Bill No. 01R-75

**TITLE:** **PRELIMINARY PLAT NO. 00026, EAGLE VIEW**, requested by Brian D. Carstens and Associates on behalf of Hoegemeyer-Palmer Construction, for 12 attached single family lots, 1 acreage lot and 1 outlot, with requests to waive sidewalks on one side of a private roadway and to waive the lot depth-to-width ratio, on property generally located at Peregrine Court and Talon Road.

Re: Preliminary Plat No. 00026  
EAGLE VIEW

**DATE:** February 21, 2001

**Preliminary Plat #00026**  
**Eagle View**  
**Talon Rd and Peregrine Ct.**

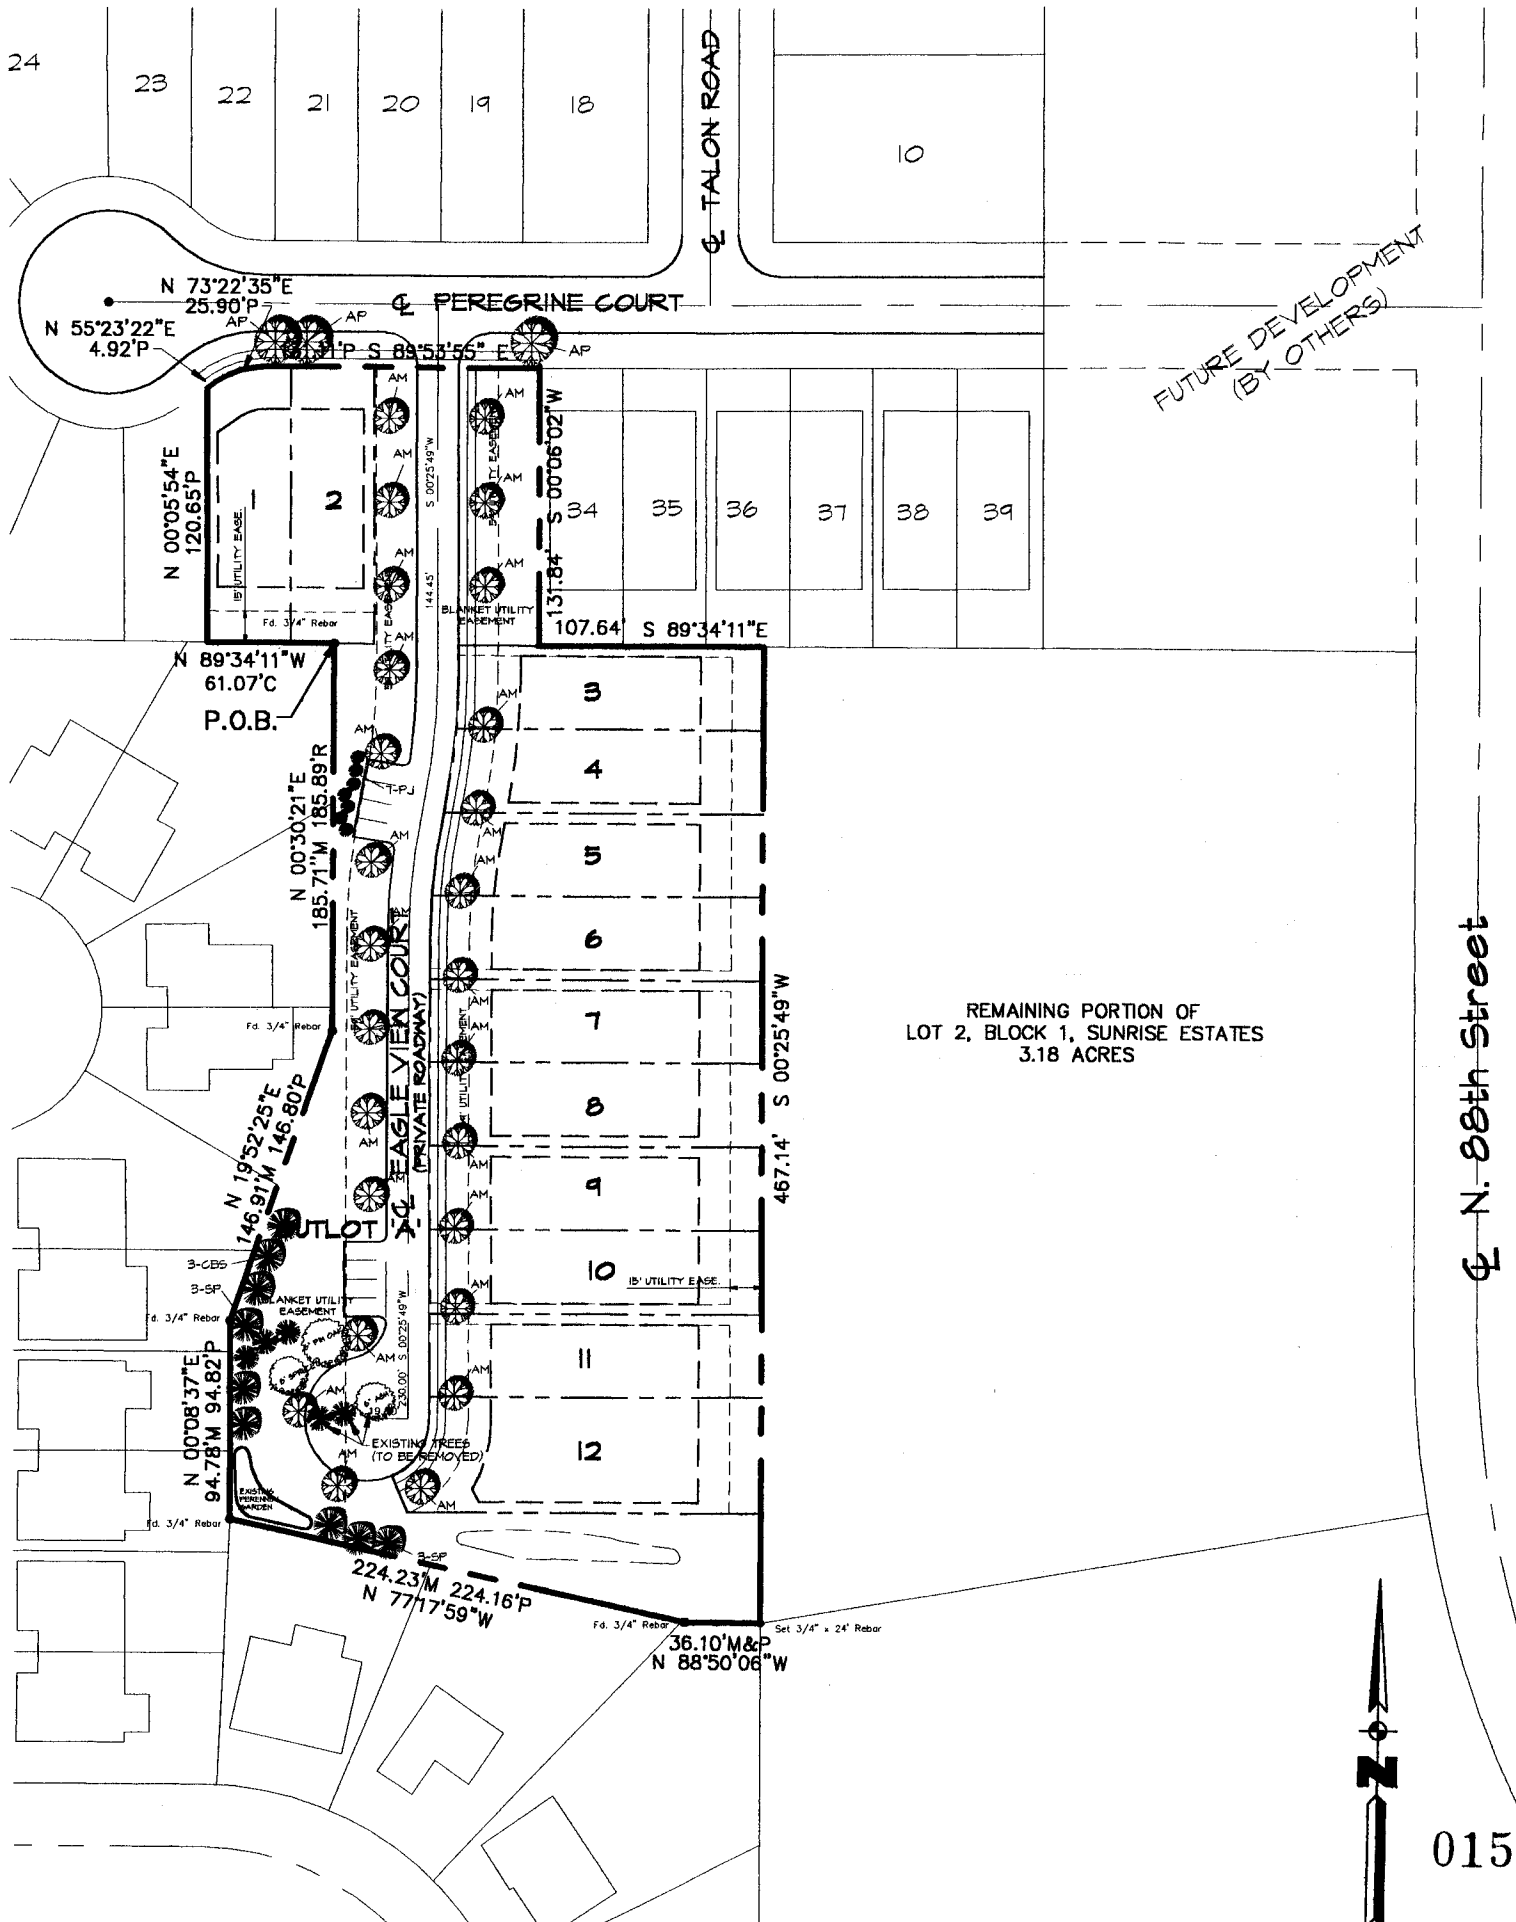
The proposed water system needs revision. A looped water system is required to provide design standard water flows.

5. The Public Works Department noted that “the water system still requires further revision. A 16" water main is anticipated to be needed along the west side of 86<sup>th</sup>. This plat shows a 8" main on the east side and connecting the water system in Peregrine Court to a main in 84<sup>th</sup> Street. The main in 84<sup>th</sup> required to provide the looped water system to provide design standard water flows must be looped to the 16" water main rather than building a second main in 84<sup>th</sup> Street. The calculations submitted show that even with an 8" main in Eagle View Court, the water design standards cannot be met without a water main loop.”

6. Section 26.23.110(d) of the Subdivision Ordinance requires north-south streets to be numbered. The proposed name of Eagle View Court is similar to Eagle Crest Road and Eagle Ridge Road, and could cause confusion.

7. The area specified in the legal description of the Preliminary Plat needs to be revised to reflect the correct area.
8. The street trees on Lots 1 and 2 on Peregrine Court need to be spaced 40' apart.

- 1.1 Revise the preliminary plat to show:
    - 1.1.1 A looped water system to the satisfaction of Public Works
    - 1.1.2 The easements requested by L.E.S.

- 1.1.3 Add a note indicating that any relocation of existing electrical facilities will be at the expense of the owner/developer.
    - 1.1.4 Rename Eagle View Court as a numbered street.

- 1.1.5 Revise the street trees on Lots 1 and 2 to be 40' apart.
2. The City Council approves associated request:
  - 2.1 Special Permit #1881
  - 2.2 A modification to the requirements of Section 26.23.140(a) the land subdivision ordinance to permit the lots along Eagle View Court to exceed the 3 to 1 lot depth to width ratio.
